File: OMB-39T-15503/Z-8505  
Planner: C. Smith

<b>TO:</b>	<b>CHAIR AND MEMBERS PLANNING &amp; ENVIRONMENT COMMITTEE</b>
<b>FROM:</b>	<b>G. KOTSIFAS, P.ENG. MANAGING DIRECTOR, DEVELOPMENT &amp; COMPLIANCE SERVICES &amp; CHIEF BUILDING OFFICIAL</b>
<b>SUBJECT:</b>	<b>APPEALS TO THE ONTARIO MUNICIPAL BOARD APPLICANT/APPELLANT: SOUTHSIDE CONSTRUCTION MANAGEMENT LIMITED. 704 AND 706 BOLER ROAD  MEETING ON JUNE 20, 2016</b>

**Re: File No. 39T-15503/Z-8505 Application for Approval of Draft Plan of Subdivision & Zoning By-Law Amendment**  
**Applicant: Southside Construction Management Limited**  
**Agent: Development Engineering (London) Limited**  
**704 & 706 Boler Road, London**

Draft Plan of Subdivision Submitted by Applicant

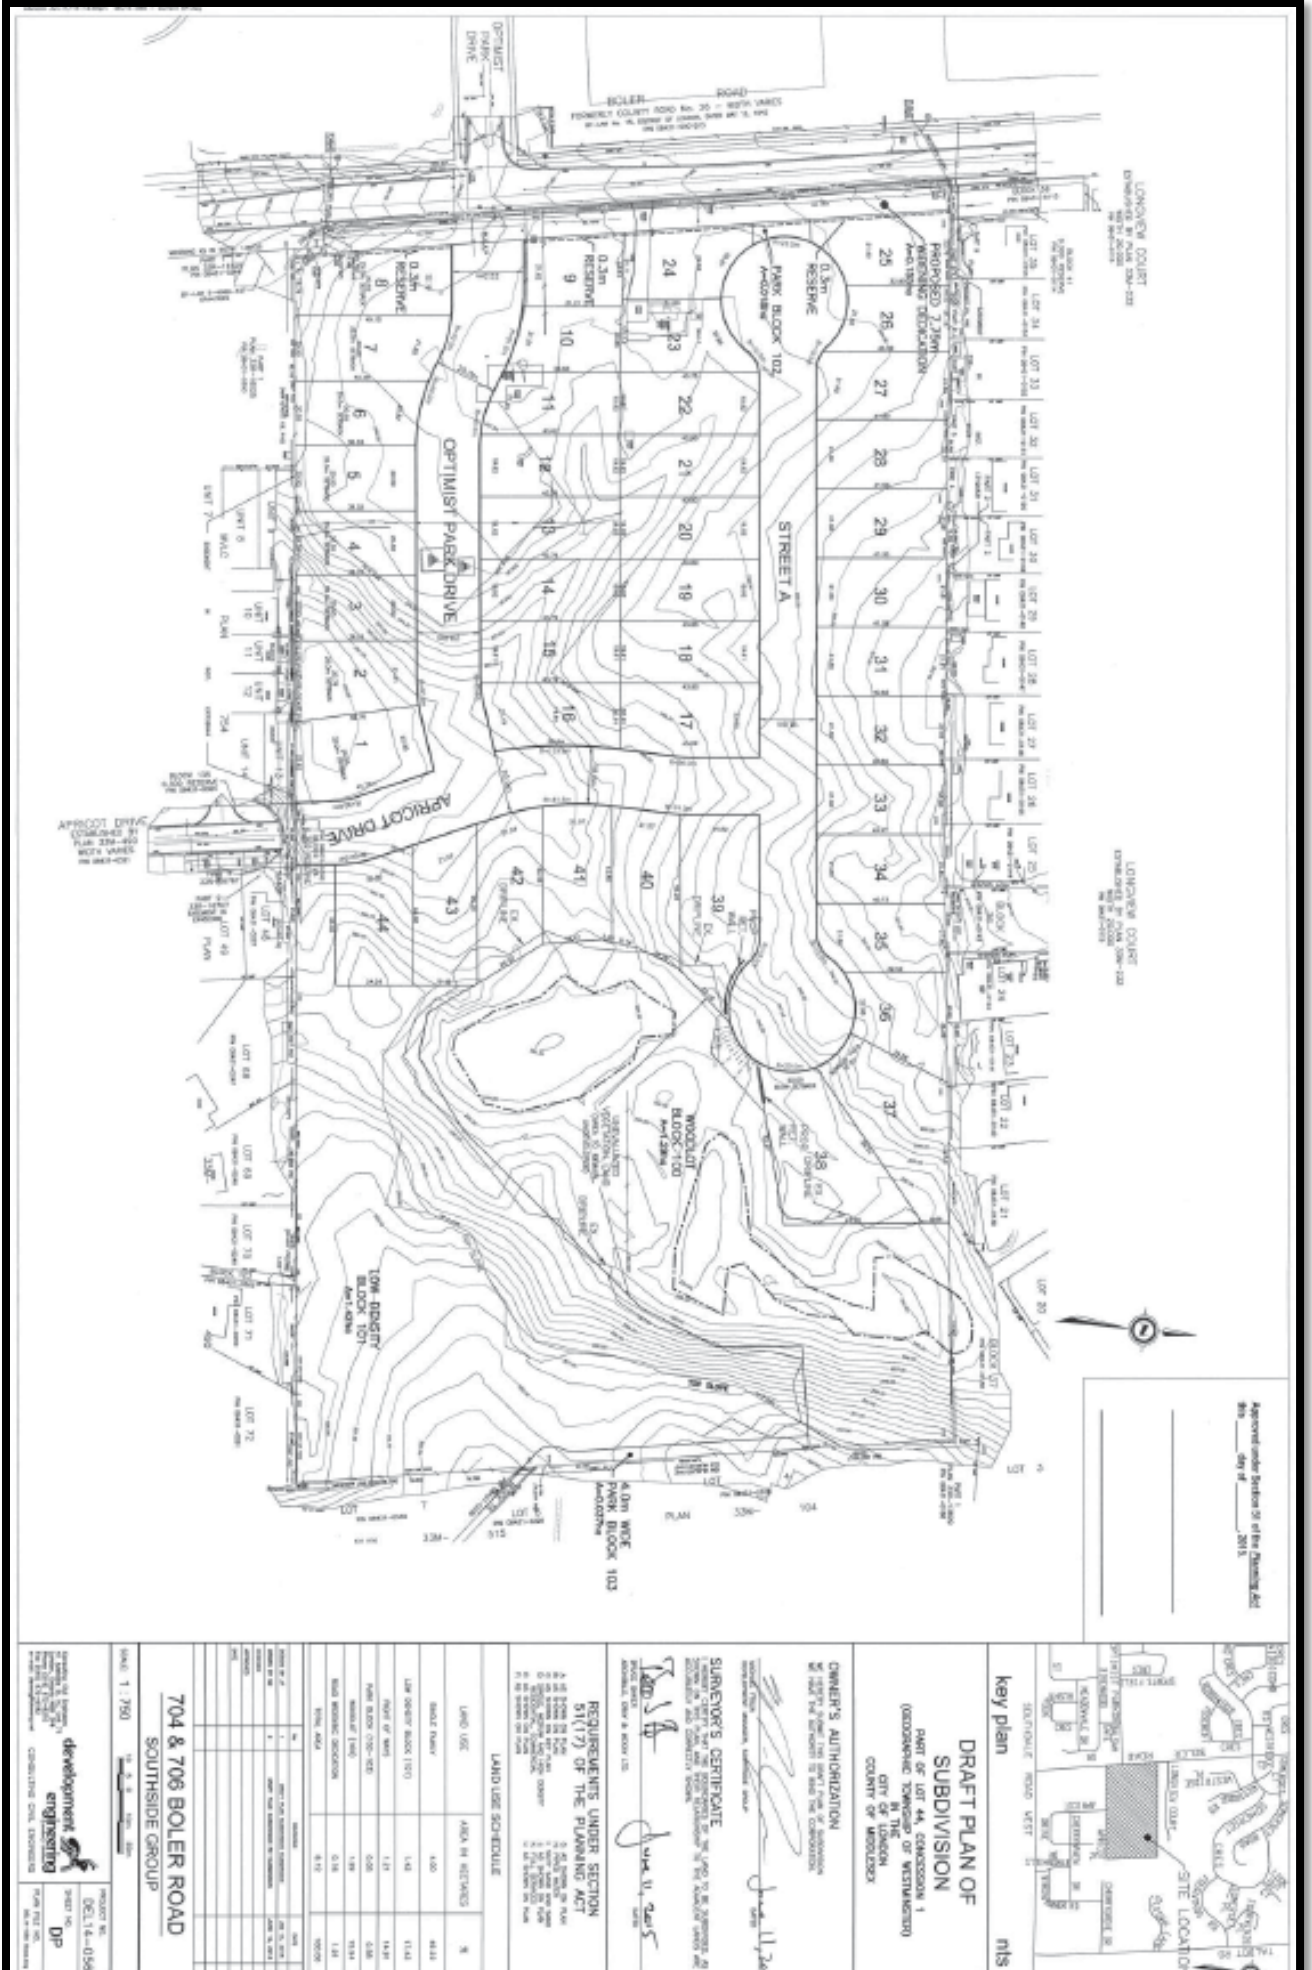
*Urban design staff have reviewed the Final Proposal Report including the proposed draft plan of subdivision for the above noted application and provide the following comments. Revisions to the draft plan will be necessary in order to be consistent with the Official Plan as well as the Council approved Placemaking Guidelines:*

- *Re-align Apricot Lane to include a window street along the woodland in order to better connect both physically and visually the existing woodland found on the eastern portion of the site.*
- *Re-align Apricot Lane to connect through block 36 to Longview Court in order to promote both vehicular and pedestrian connectivity among the greater community.*
- *Ensure any development along the Boler Road frontage is oriented towards the street as noise attenuation fencing along arterial roads is strongly discouraged, as per Official Plan policy. In order to avoid noise walls, consider including a medium or low density block along the Boler Road frontage that will allow for street oriented development.*

Figure 1 study area appears to be in 6b P0238 Dreimanis: St. Thomas West.

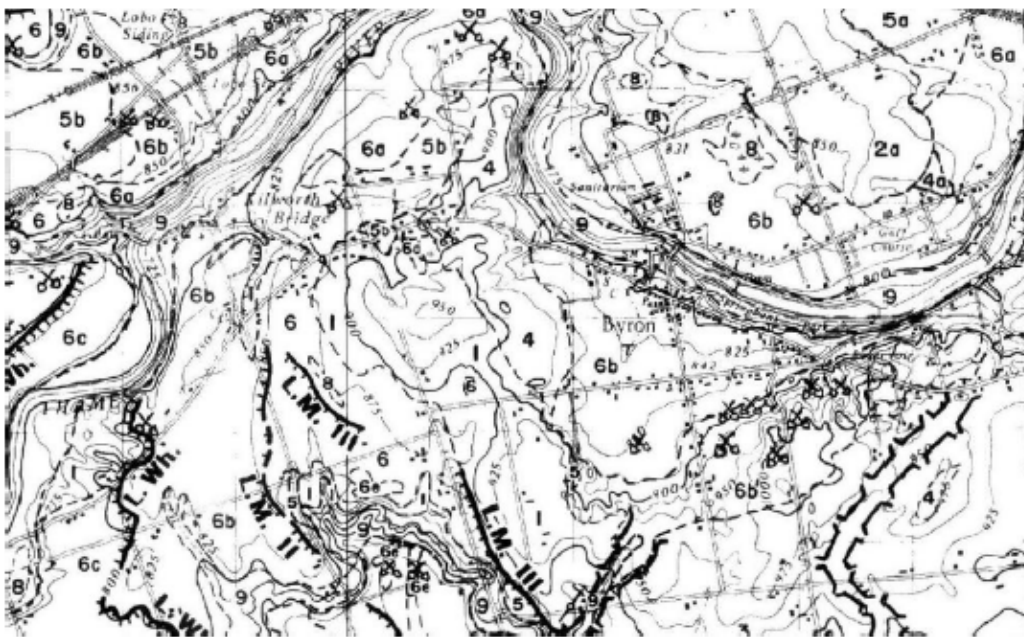
The scale and location of the map is not appropriate for the site size and location. It is difficult to determine the physiography at the site from the diagram or how this impacts the hydrogeologic setting. The statement 'glacial ice sheets advanced several times into the southern part of the province from various directions and then receded... (which is included in all exp site descriptions)' conveys nothing about the site or how it affects the site hydrogeology. The description does not reveal the intent of the inclusion of the topic. For example, the site is likely on the Ingersoll moraine. Thick sequences of gravel, sand and diamicton or till might be expected at this site. Also due to the proximity of the Ingersoll moraine (what till might be expected associated with the Ingersoll moraine) possibly at depth. Remember, the hydrogeology- aquitards and aquifers and their characteristics are being described - this is a geotechnical description. See Conservation Ontario guidelines for proper completion of this section.

*Surficial geology should be interpreted to the landscape on the cross sections somewhere. Tie the surficial geology to the MOECC data and make an attempt at an interpretation beyond the site which includes the MOECC data. What is present at depth? What is the rationale for the borehole depth?*

Figure 2 OGS Open file report 5182. E.V. Sado (Station 2 Byron Pit Lot 41, Con 1

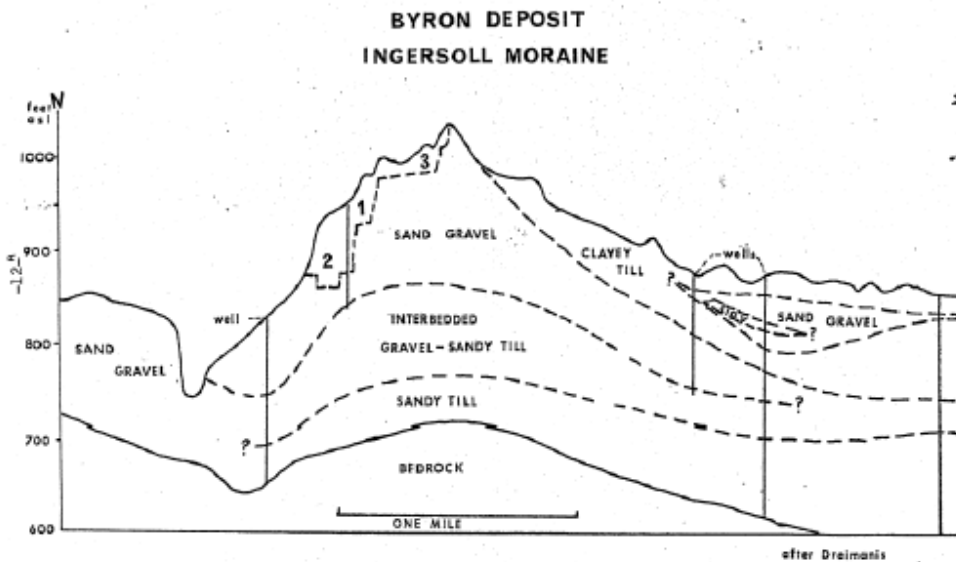
*Well Survey:* Well data for private wells within 500 m of the margins of the site is to be used. The proponent may refer to published reports regarding typical hydraulic conductivity properties for the geologic units or utilize data from field tests (single well response tests) conducted on monitoring or test wells on the site. The well test included in the appendix appears to be incomplete. Both Kh and Kv estimates should be provided where available and discussed in the text. The pump test included in Appendix C is not discussed. From the borehole log for BH5 it's not clear where the water table is located. Nor is it clear that well screen is located in the saturated zone. It is not properly documented to understand if the minimum requirements of the test were met.

The site is located on the Ingersoll moraine. Open file report 5182. E.V. Sado states "localized outwash deltas were developed along the lake margins at Byron and is obvious in the regional topography. The Byron deposit described above is from the Byron Pit east of the property. These deltas contain the majority of coarse aggregate available in this area.
